## T echnical T ip

FILE	TAOSC-TT-20050304-01
DATE	04 February 2005

<b>PRODUCT</b>	Scan Converter
<b>Part No:</b>	23148027

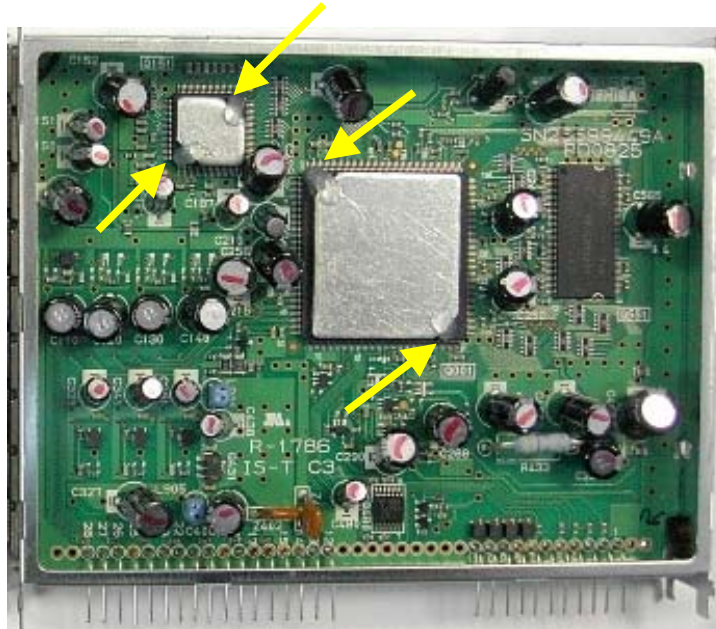
Repair the Scan converter board by:

- 1) Re-solder those IC Q001, Q151, Q551 and some other components if needed. (Use Lead Free Solder)
- 2) Add heat sink to IC Q001; Q151.
- 3) Replace C184, C187 as show in below photo

Add silicon to prevent drop off

Location	Description	Part No
C184	22uF 16V (Electrolytic)	2479 4220
C187	22uF 16V (Electrolytic)	2470 4220

Description	Part No:
Silicone ( TSE 3843-W- Adhesive )	23960136
